Staff Report

Re: PLNPCM2021-00545 – TAG 400 W Planned Development

TAG 400 W PLANNED DEVELOPMENT

Property Address: 765 North 400 West **Parcel IDs:** 08-25-376-018-0000; 08-25-376-029-0000 **Zoning District:** MU (Mixed Use) **Master Plan:** Capitol Hill

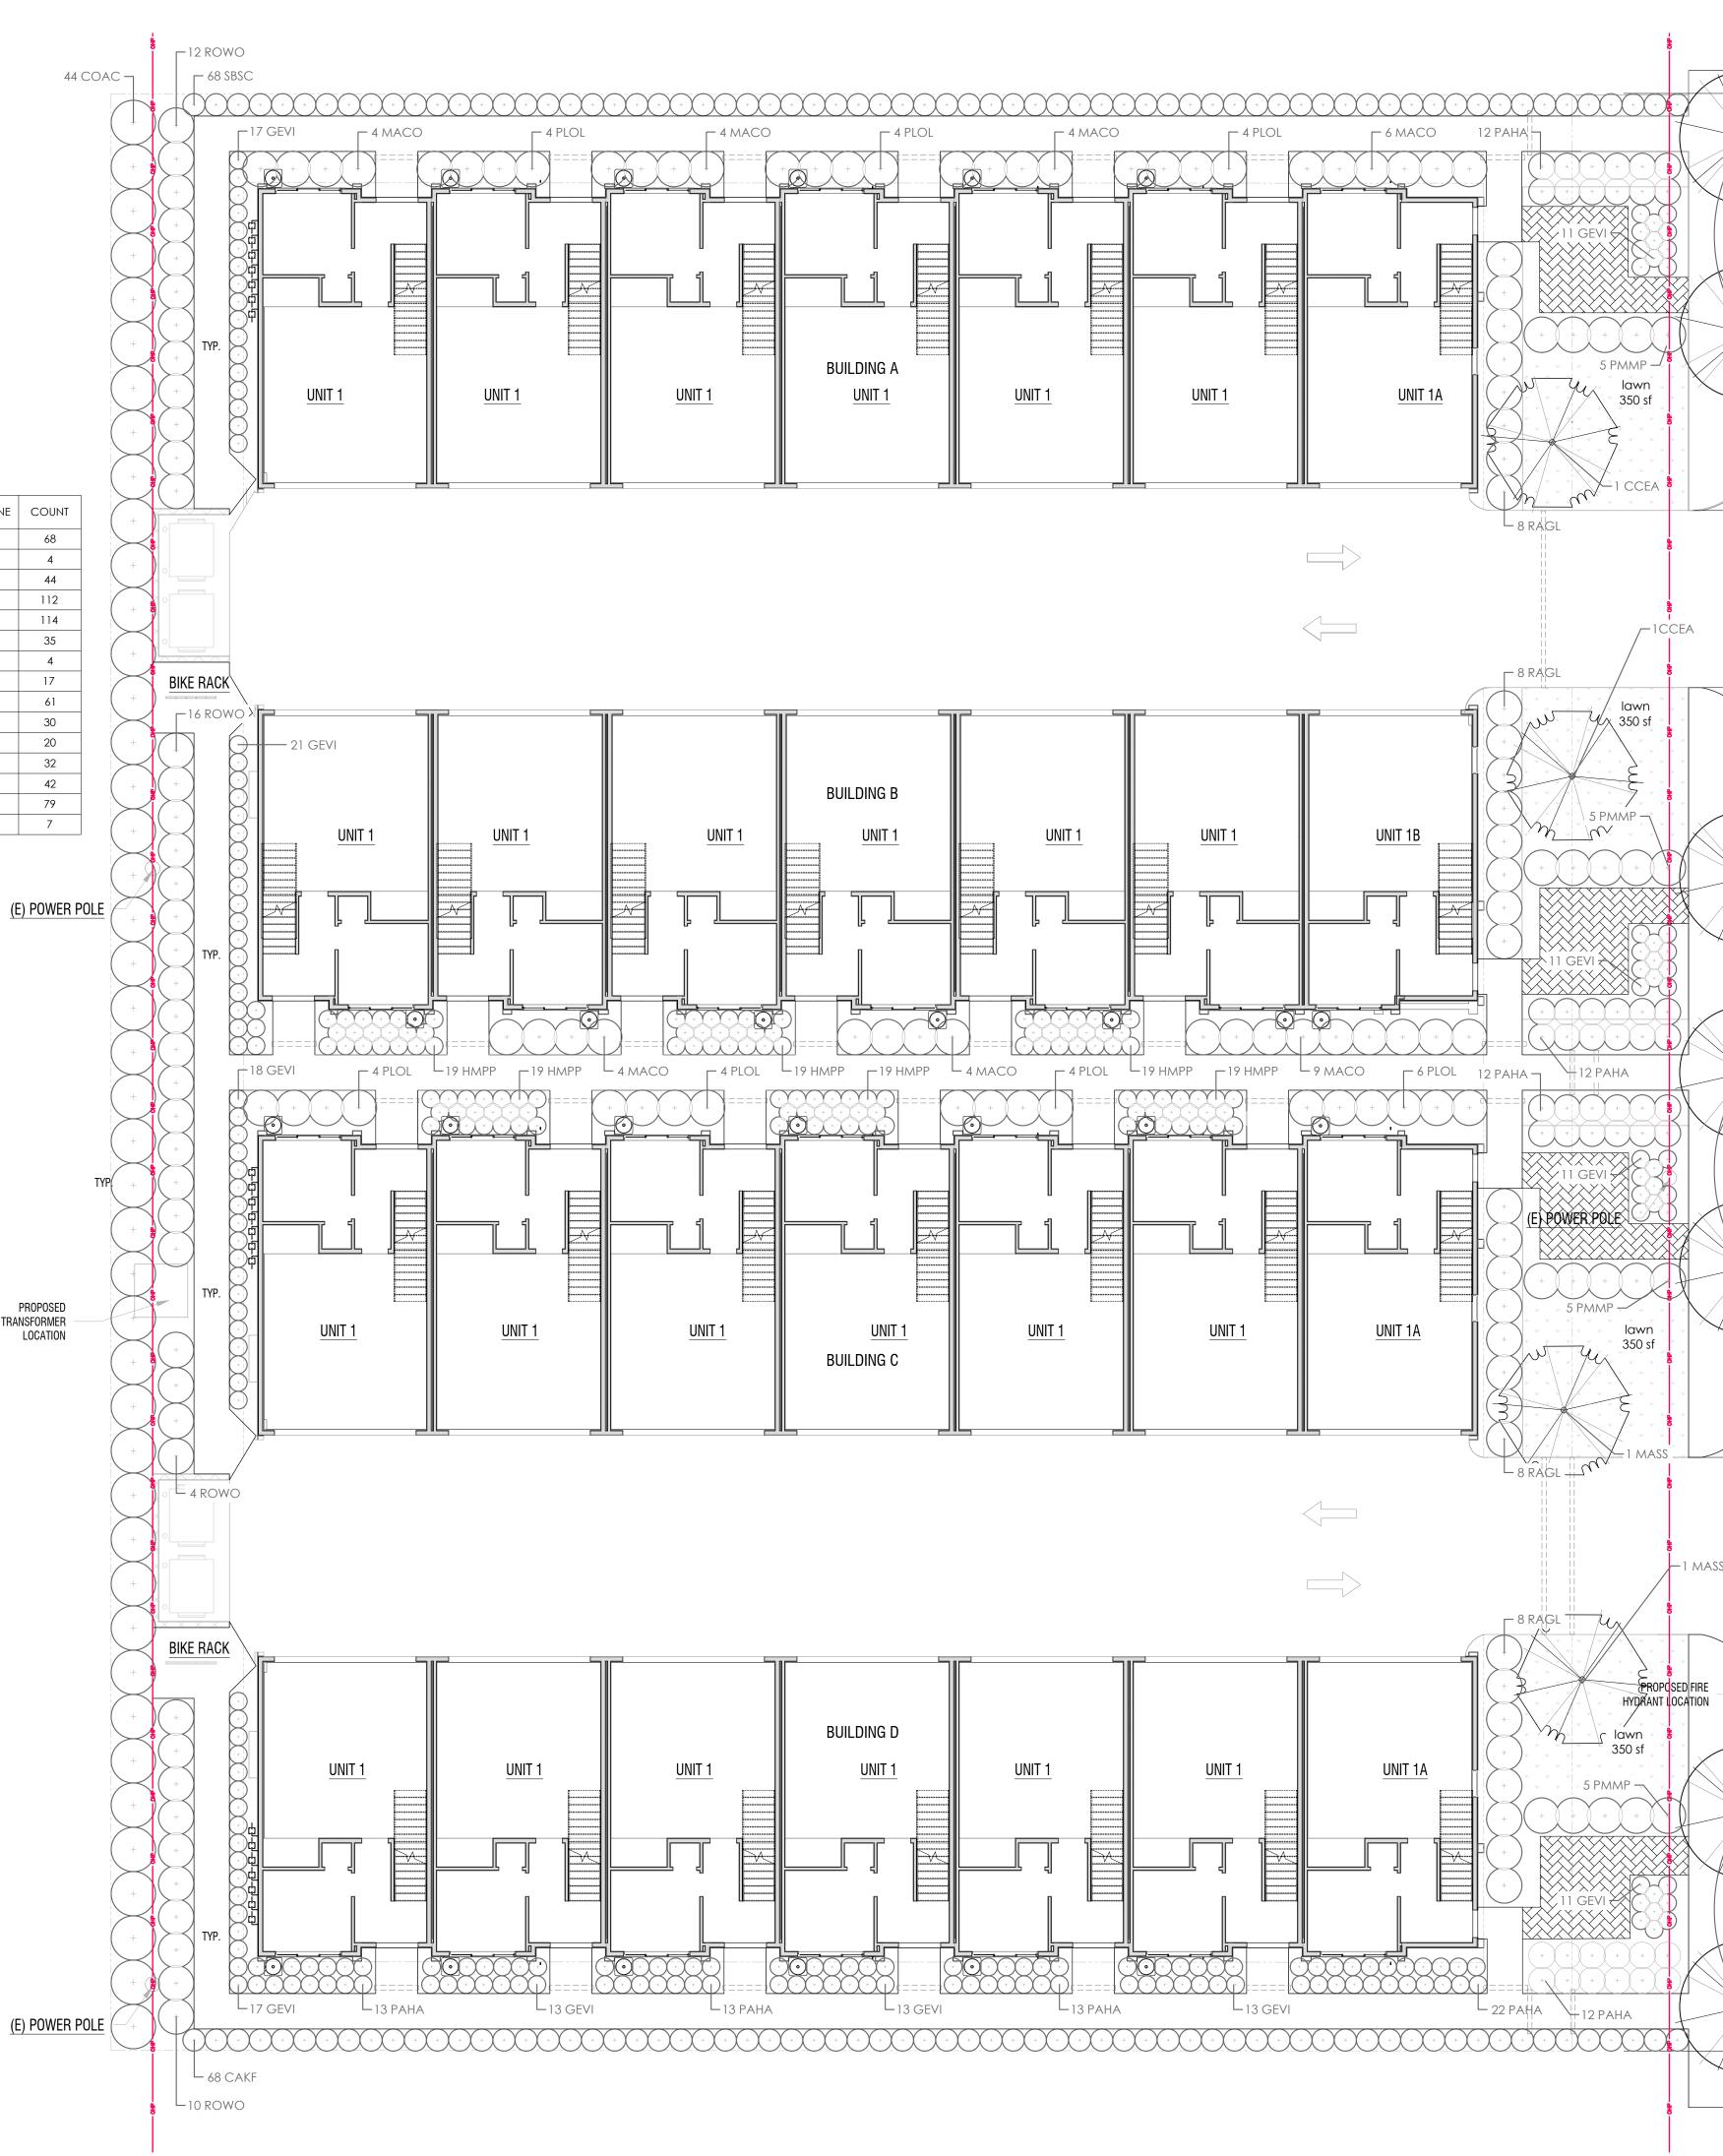
- 1. Urban Forestry calculations:
- Salt Lake City Urban Forestry Program requires one tree for every 30 feet of street front.
- o The Lot is 165' x 221'. There is 221' of street frontage. 220'/30' = 7.37 trees per street front, which rounds down to 7 trees per street front. There are 7 trees shown per street front, thereby meeting the requirement.

- The park strip tree reflects the following city requirements: o 400 W: 3-5' park strip with overhead wires = small tree at maturity (less than 30 ft). Zelkova serrata 'Wireless' is selected, with a mature height of 24 ft.

- Zelkova serrata is listed in the "SLC Plant List and Hydrozone Schedule 2013" as Td4.
 Water conserving plant list calculations:
- There are 203 shrubs indicated on the plan (COAC, MACO, PMMP, PLOL, RAGL, ROWO). 173 of these 203 shrubs are on the SLC plant list. Therefore, 85% of shrubs are selected from the water conserving plant list, which exceeds the 80% requirement.

- 3. Park strip ground surface treatment plant coverage calculations:
 The plantings within the park strip are low growing perennials, so will not exceed 22" height. Coverage within 3 years should be 45%, which exceeds the 33% minimum. All plants in the park strip are water wise plants found in the SLC plant list.

- 4. Open Space Calculations (min 10% of lot area required):
- Lot area: 36447 s.f
 Ground floor lawn and walkways: 2963 + 3688 s.f. (=18% of lot area)
- Ð partr \triangleleft IJ 765 North 765 N 400 W Salt Lake City, U SLC () Revision/Issue No. ./../VODA forms/voda_logo_02A.jpg /ODA Landscape + Planning 159 West Broadway #200 Salt Lake City, Utah 84101 801-520-5382 www.vodaplan.co Planting Plan L-001 P21-28 Date 2021-03-29 Scale 3/32" = 1'
